From: John Adams <jeadams60@gmail.com>
Sent: Saturday, March 3, 2018 12:55 PM
To: Mattingly, Laura L
Cc: Teri Adams; dougflaherty@twc.com
Subject: Case 17zone1049L
Attachments: img20180303_12532076.pdf

We are concerned about the hazards of the proposed entrances to the new facility at the corner of Bardstown Road and Watterson trail.

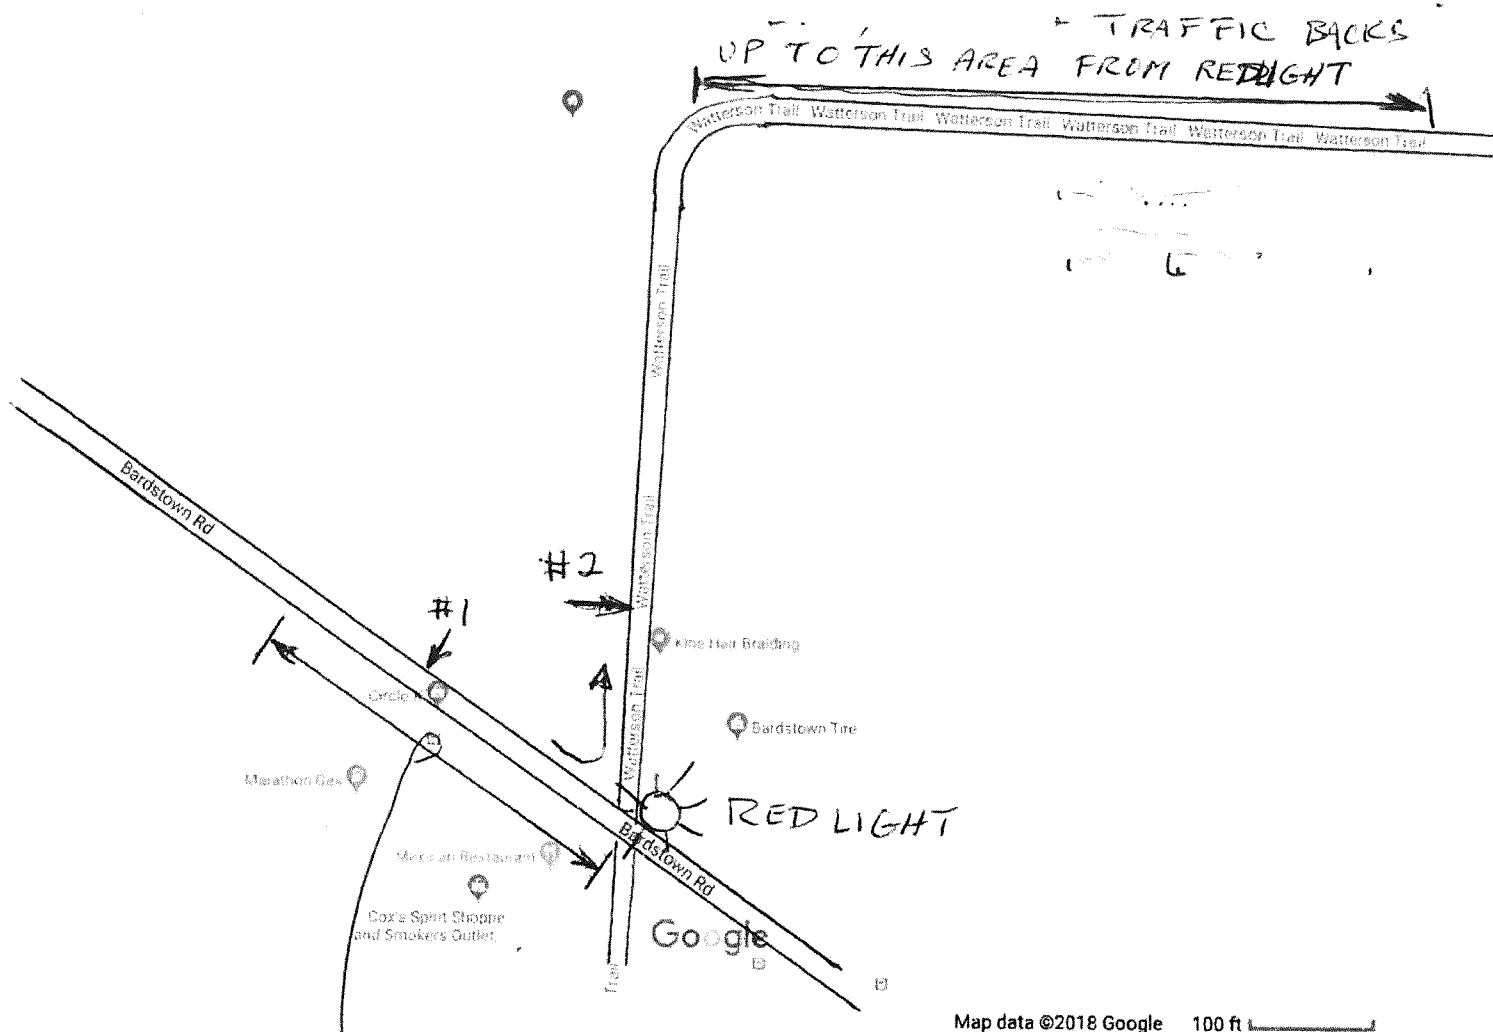
1. Proposed Bardstown Road entrance:

A. There is a lot of fast traffic on Bardstown Road. Cars going North wanting to turn onto Breckenridge Lane switch lanes quickly into the turning lane as soon as they pass over Watterson Trail. They don't slow down. Anyone coming out of the new facility will be turning into fast traffic. I have walked on Bardstown Road several times and have almost gotten run over at that location.

B. Also, some cars try to cross over to the South direction, and have wrecks on Bardstown Road. This will make that worse.

2. Proposed Watterson Trail entrance:

There is a lot of traffic that backs up from the Redlight all the way around the corner on Watterson Trail in front of my house every day. If someone tries to cross that line of cars to get into the proposed entrance, it will cause traffic to back up through the redlight causing grid lock. No one will be able to let them cross through because it doesn't move until that redlight changes which only lets through a few cars at a time.

If they are coming from the south bound turning lane onto Watterson trail, it will be worse. A long "train" of cars goes through that light when it changes. It will back up through the light and stop the north bound Btown road flow. People are impatient at that light because it takes a long time to change. a lot of people run it even as its turning red. When that happens, it will stick out into the main intersection.

TRAFFIC BACKS UP TO HERE EVERY
MORNING AND AFTERNOON IN THE
TURNING LANE

#1 PEOPLE HAVE WRECKS TRYING TO GET
ACROSS THIS LANE

#2 IF SOMEONE WANTS TO ENTER THIS ENTRANCE,
THE TURNING TRAFFIC OFF OF B-TOWN RD
ONTO WATERSOON TRAIL WILL CAUSE A BACKUP
THROUGH THE LIGHT, AND RESULT IN GRIDLOCK
